DUANE ARNOLD

SITE-SPECIFIC OFFSITE RADIOLOGICAL
PREPAREDNESS ALERT NOTIFICATION SYS
QUALITY ASSURANCE VERIFICATION

DUANE ARNOLD ENERGY CENTER
SITE-SPECIFIC OFFSITE RADIOLOGICAL EMERGENCY
PREPAREDNESS ALERT AND NOTIFICATION SYSTEM
QUALITY ASSURANCE VERIFICATION

September 14, 1989

COMPARATIVE OSPM RESULTS, PARTIALLY HILLY TERRAIN (WS-3000 SIREN)

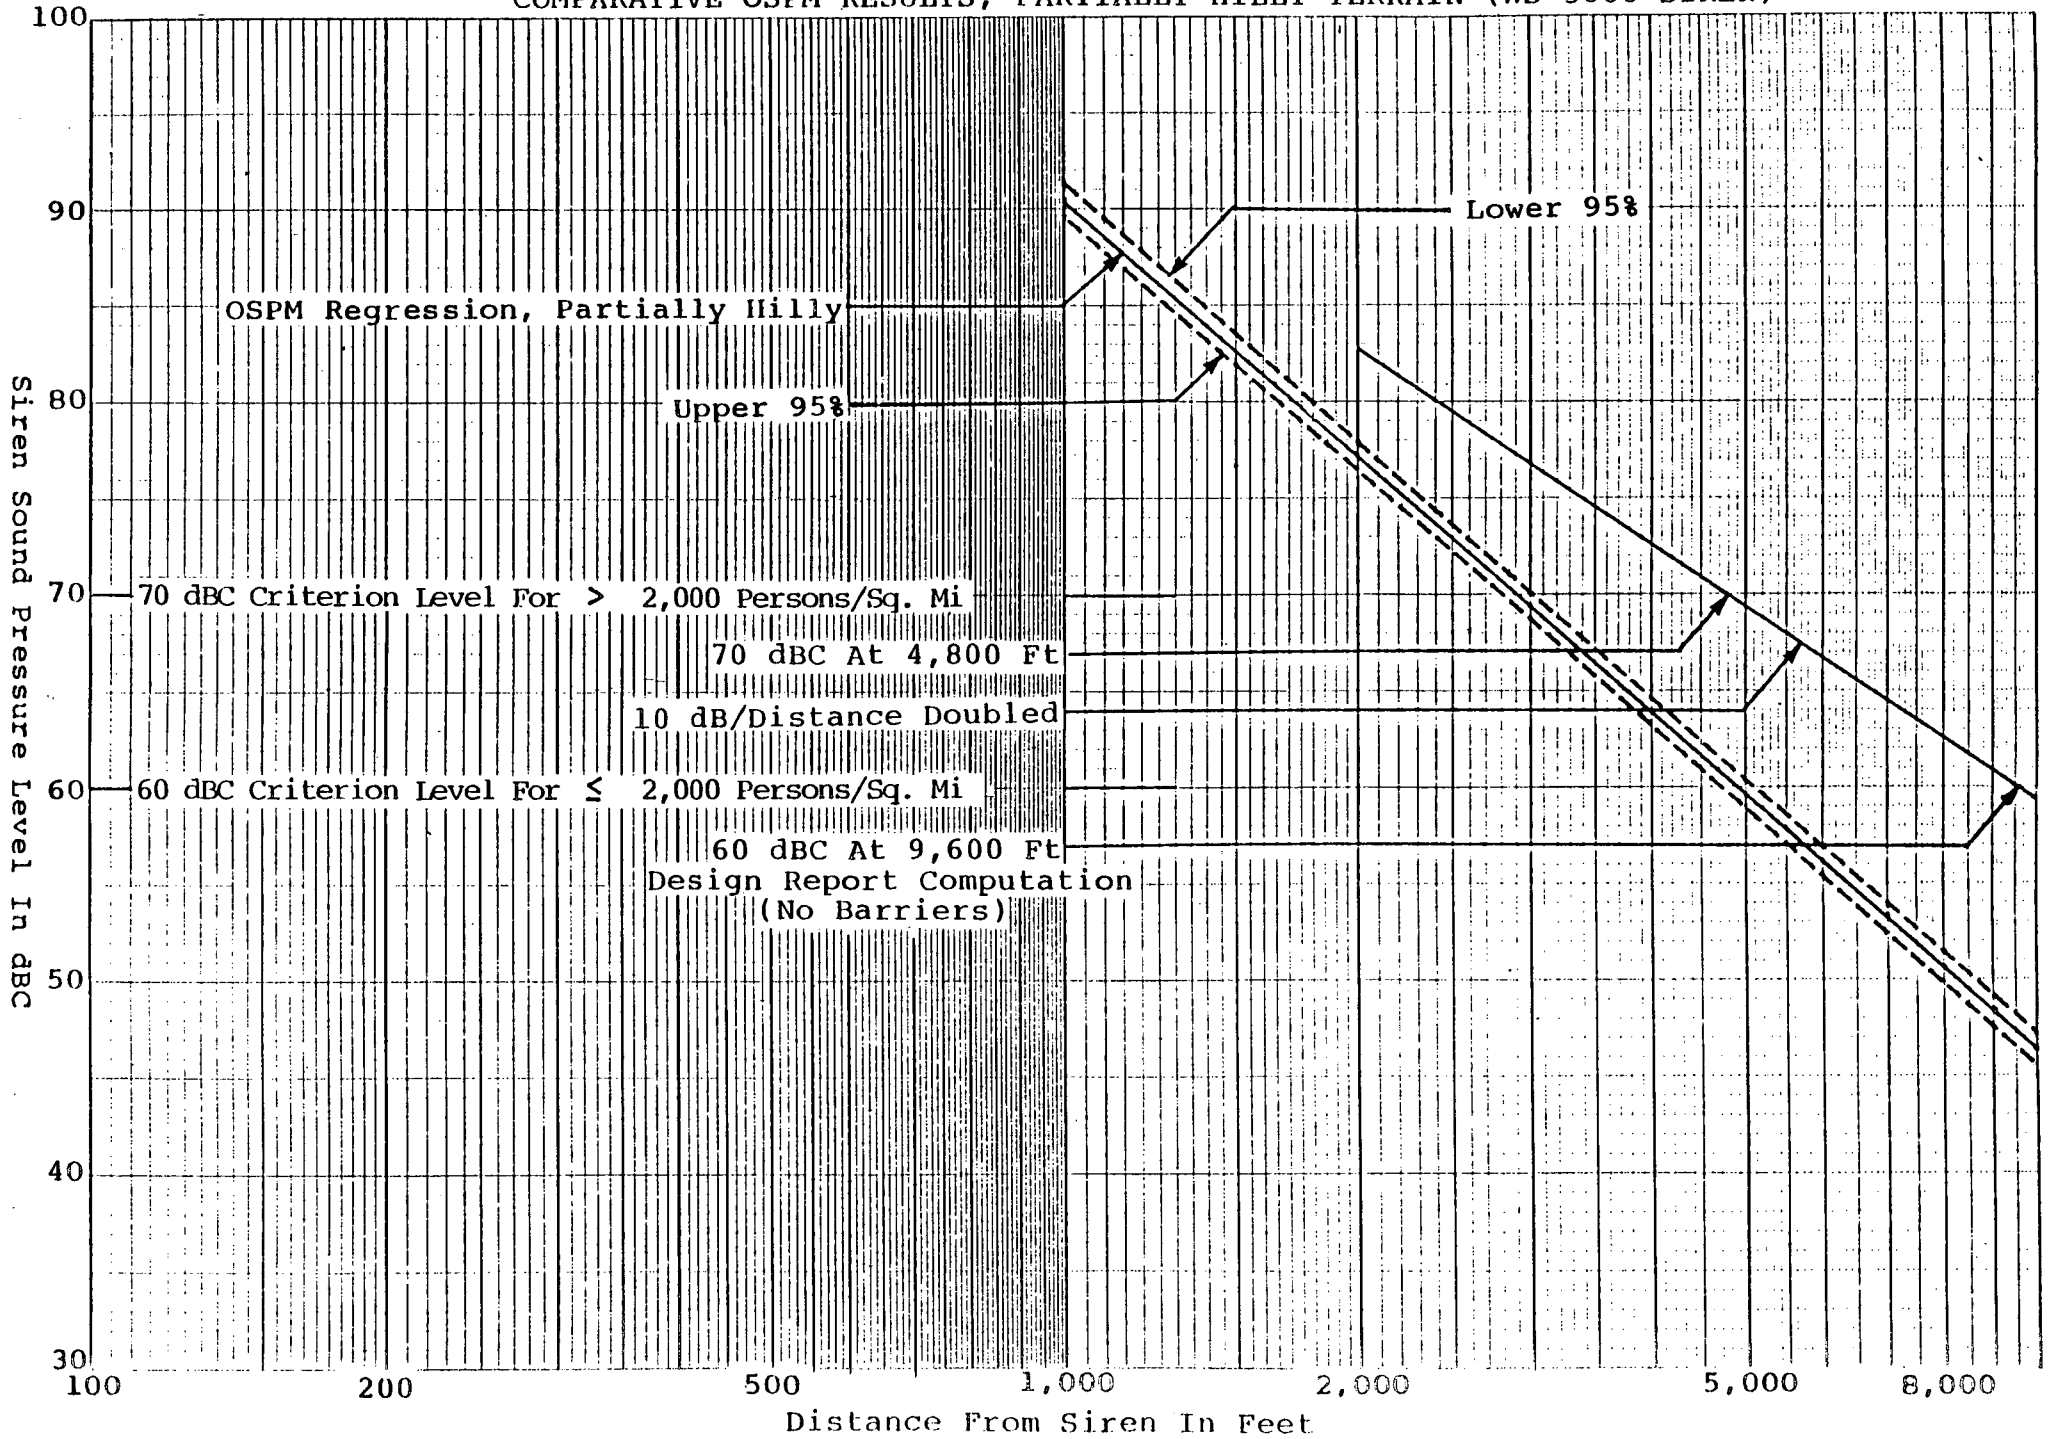
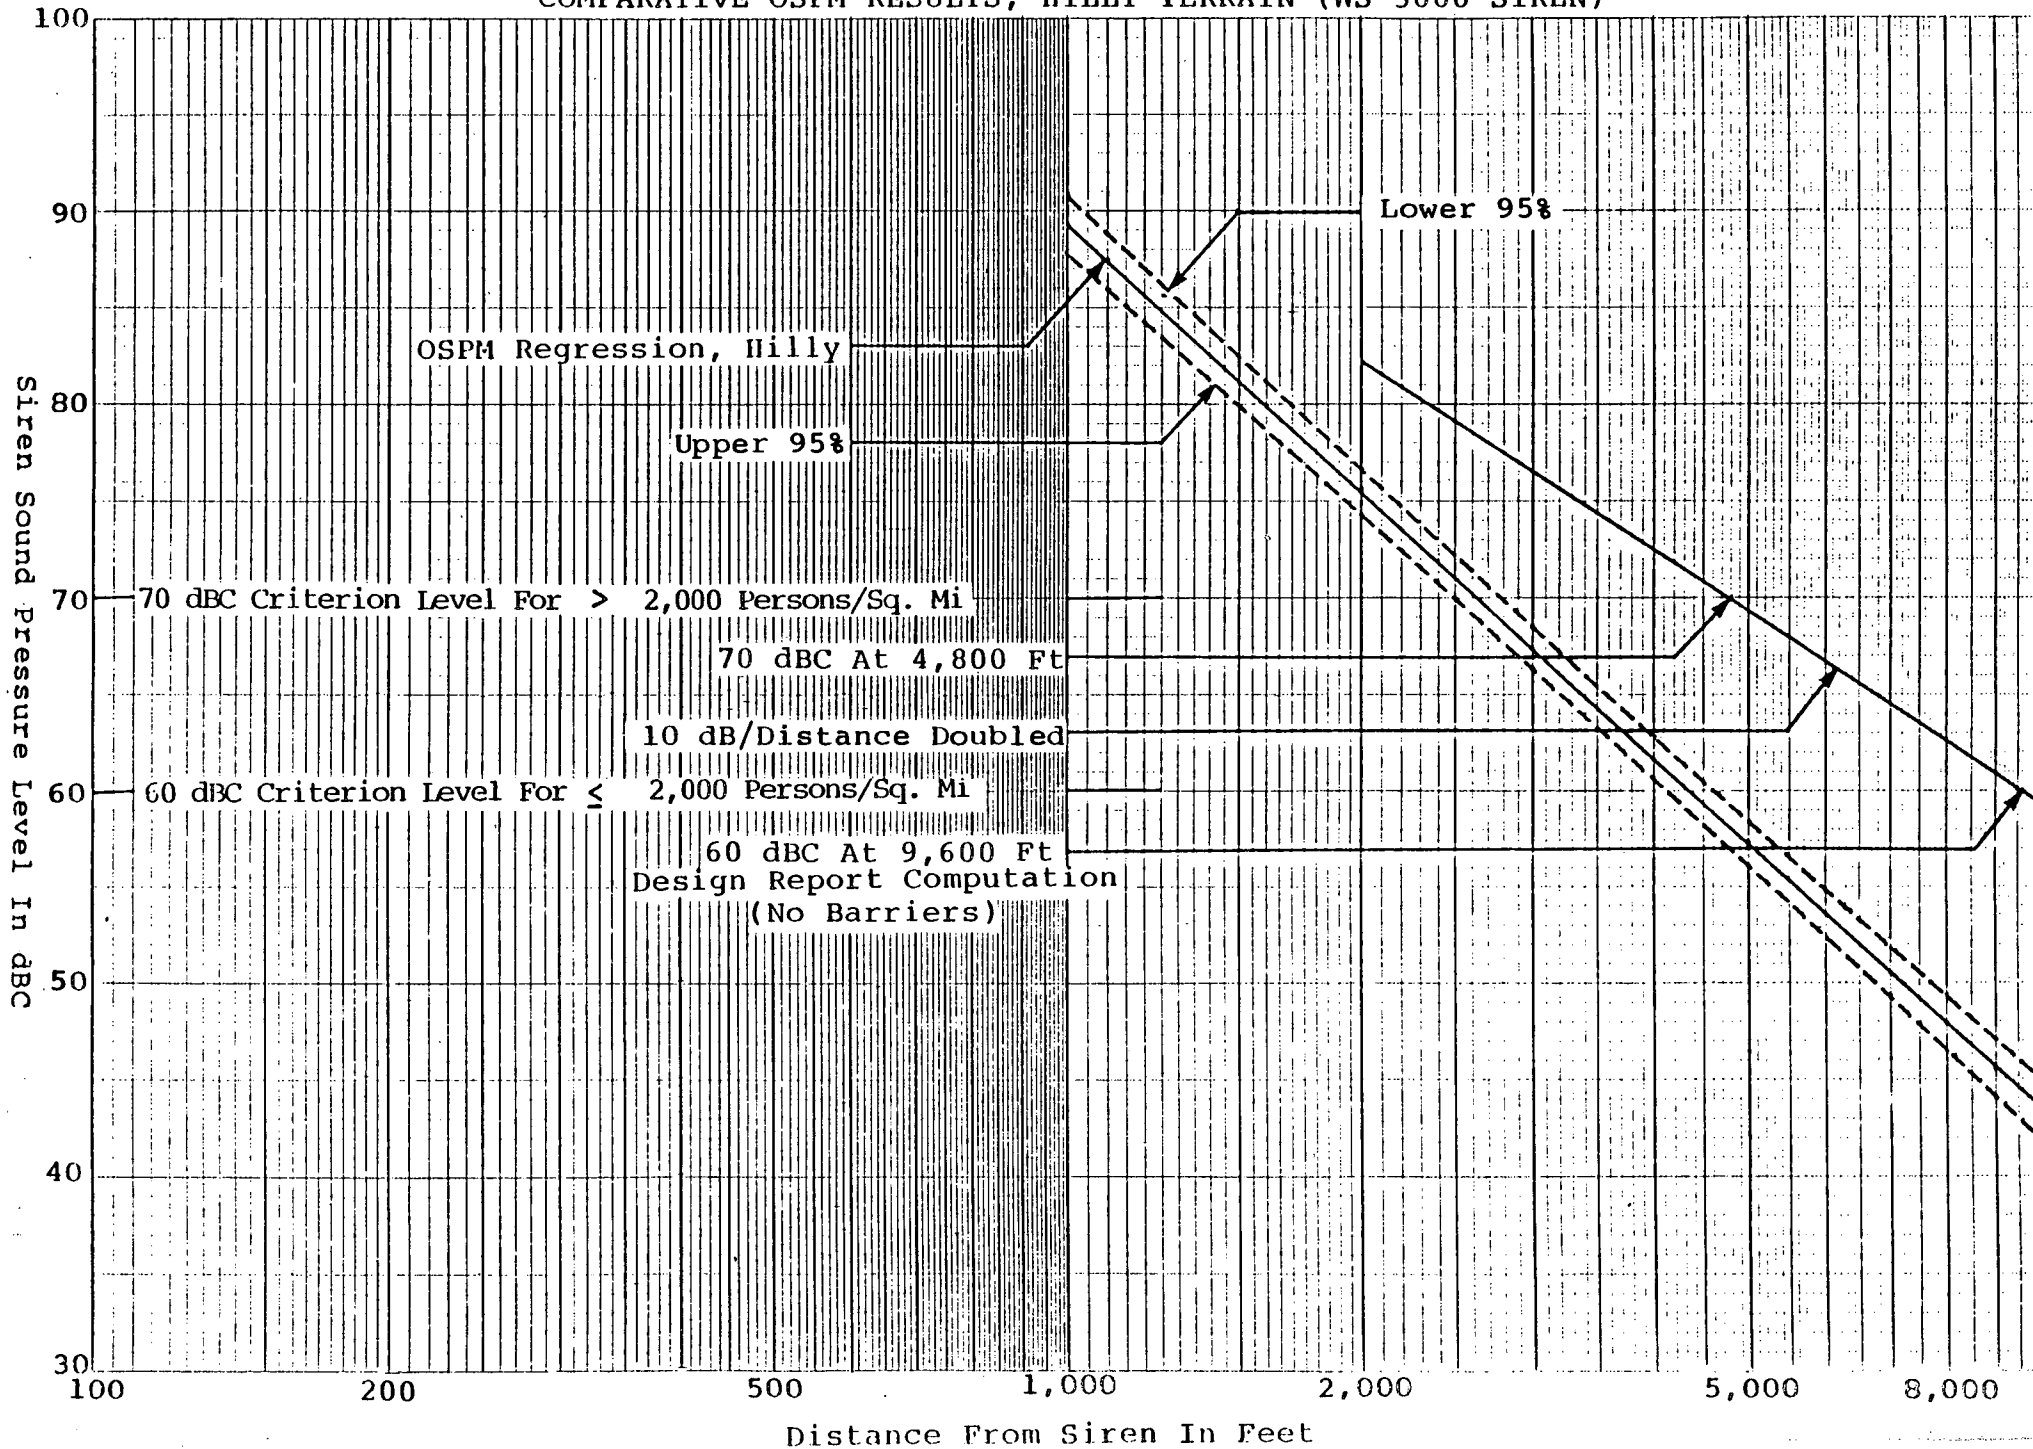
The OSPM regression results of the siren sound pressure levels are presented in Figures 3 through 8 of this report. Also depicted are the ranges of 60 dBC and 70 dBC as calculated by the licensee using the 10 dB loss per distance doubled attenuation rate with no barriers. The following table summarizes the estimated effective ranges of 70 dBC and 60 dBC over the various terrain classifications:

Some general observations can be made concerning the siren range comparisons. The 60 dBC and 70 dBC ranges estimated by the licensee for the FS-1003 sirens over partially hilly and flat terrains are similar to OSPM results. With proper terrain adjustments, the effective 70 and 60 dBC ranges would be greatly reduced as demonstrated above.

The licensee's estimated 60 dBC and 70 dBC ranges for the WS-3000 sirens, however, are very liberal compared to OSPM results. This is due to the higher operating frequency of the WS-3000 siren which suffers much higher attenuation rates through atmospheric absorption and other excess attenuations. The effective range of the WS-3000 siren is therefore substantially reduced from the 10 dBC rule which is based on operating frequencies of 500 to 800 Hz. This is particularly so for the 60 dBC range, since the attenuation rate in the 1,000 Hz octave band is typically much greater than 10 dB per distance doubling at large distances (5,000 ft. and beyond).

These derived radii confirm that on the average, the Design Report siren ranges are liberal when site terrain and weather conditions are taken into account.
